Project	IEEE 802.16 Broadband Wireless Access Working Group < http://ieee802.org/16 >	
Title	Comments on channel modeling	
Date Submitted	2007-05-03	
Source(s)	Dean Kitchener, Kelvin Au, Robert Novak, Mo-Han Fong, Sophie Vrzic, Jun Yuan, Peiying Zhu, Wen Tong, Jianglei Ma	Voice: +44-1279-403118 Fax: +44-1279-402100 mail to: deank@nortel.com mhfong@nortel.com
	Nortel	
Re:	This is a response to a call for contributions http://www.ieee802.org/16/tgm/docs/80216m-07_014r1.pdf	
Abstract	Recommendations for user speed distribution and wideband channels (>5MHz)	
Purpose	For consideration when specifying channel models for the evaluation methodology	
Notice	This document has been prepared to assist IEEE 802.16. It is offered as a basis for discussion and is not binding on the contributing individual(s) or organization(s). The material in this document is subject to change in form and content after further study. The contributor(s) reserve(s) the right to add, amend or withdraw material contained herein.

Comments on channel modelling

Dean Kitchener, Kelvin Au, Robert Novak, Mo-Han Fong, Sophie Vrzic, Jun Yuan, Peiying Zhu, Wen Tong, Jianglei Ma
Nortel

Figure 1 – HSDPA user speed distribution

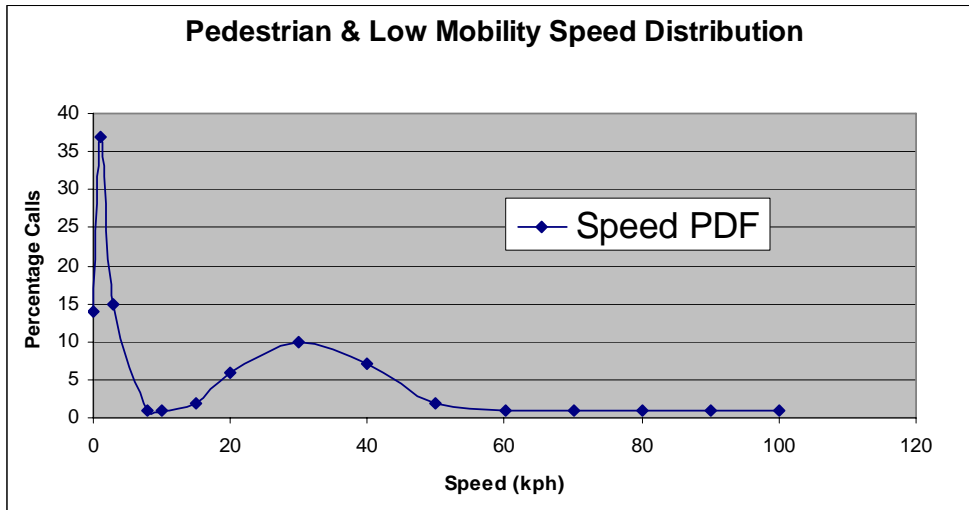
The key thing to note for all of the above recommendations is that there are no stationary users. For IMT-Advanced, delivering high data rate multimedia services, it is expected that many users will be stationary, since the user will need to look at the information being received. This has been taken into account in the specification of parameters for HSDPA simulations where the user speed distribution given in Figure 1 is used [2] (see also Table 5). In this case it can be seen that 14% of users are stationary and 51% of users have speeds ≤ 1 kph. It is recommended that this distribution also be used for macrocellular system simulations for IEEE 802.16m. For the hotspot layer this distribution will be different again, where in this case all users are likely to be walking or stationary (all ≤ 3 kph).

For system simulations, the user speed will be completely independent of the actual channel characteristic (TDL model) at each location. It is therefore recommended that the TDL model assignment probability be decoupled from the user speed probability. It is also recommended that for stationary users the Doppler spectrum for the taps should be modified to that used in [3] for fixed links.

The HSDPA speed distribution contains a large number of user speeds. To simplify the system simulation these can be reduced to a smaller set, but with a similar probability distribution:-

Speed (km/h)	0	3	30	120
Percentage	51	17	25	7

Figure 2 – Magnitude of the spaced-frequency correlation function for ITU Ped B

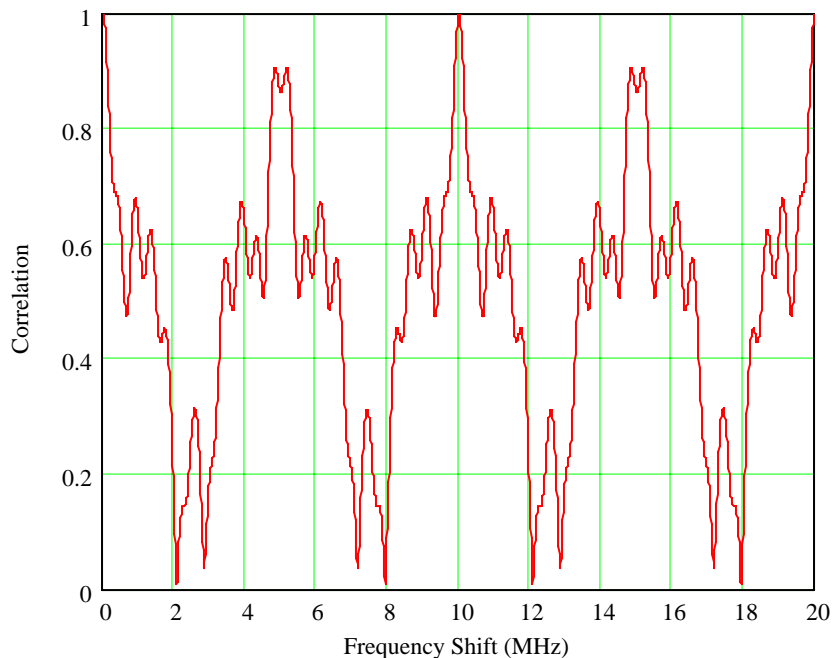
The function is shown plotted for the ITU Ped B channel in figure 2, for bandwidths up to 20MHz. It can be seen that it has a period of 10MHz, but even at 5MHz the correlation is high. This clearly shows the need for improved models for bandwidths greater than 5MHz.

Figure 3 – Spaced-frequency correlation function for ITU Ped B with the powers of taps 5 and 6 set to zero

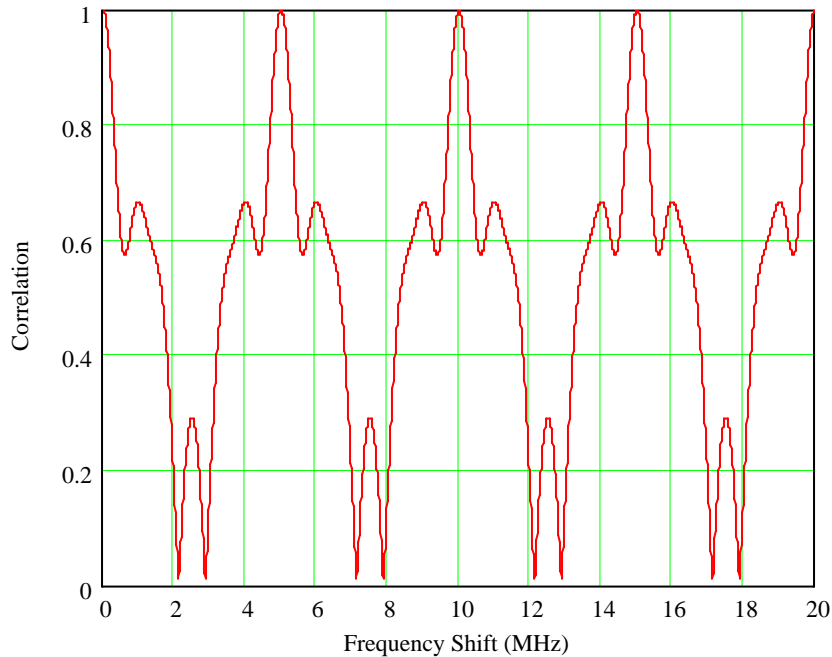
We also note that if the tap powers for taps 5 and 6 (longest delayed components) are set to zero we would expect a period of 5MHz, since taps 2-4 all have integer values for n at 5MHz. This is shown to be true in figure 3.

Figure 4 – Space-frequency correlation function for modified ITU Ped B TDL model

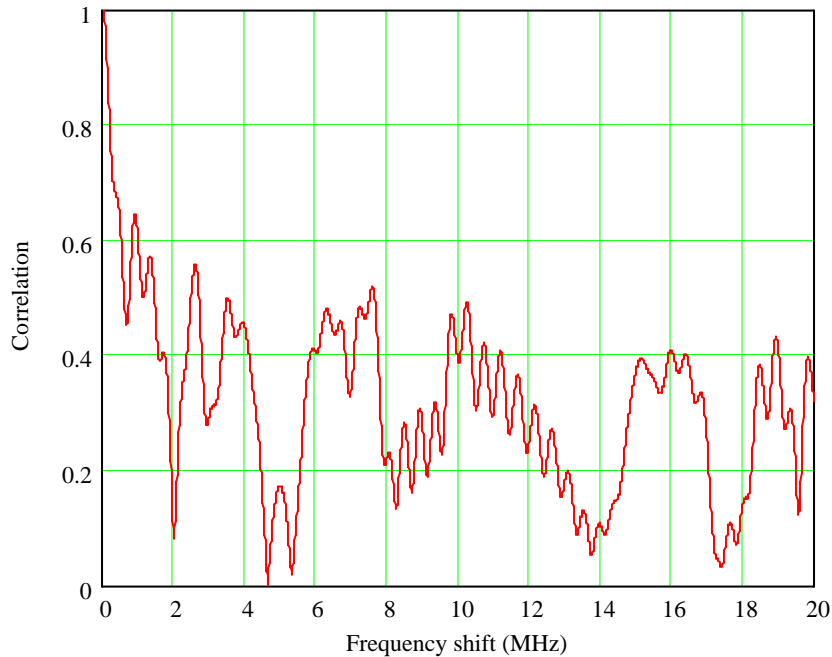
As an example, the spaced-frequency correlation function for the modified ITU Ped B model is shown in figure 4, where N=2 and the symmetry constraint is imposed. It can be seen that this is no longer periodic, and the correlation generally decreases with increasing frequency offset. Clearly, this is a good result even with the symmetry constraint imposed.

It is recommended that the modified ITU models be used for wideband channels (i.e. for bandwidths greater than 5MHz and up to 20MHz). It is recommended that the modified models with $N=2$ be used, without the symmetry constraint.
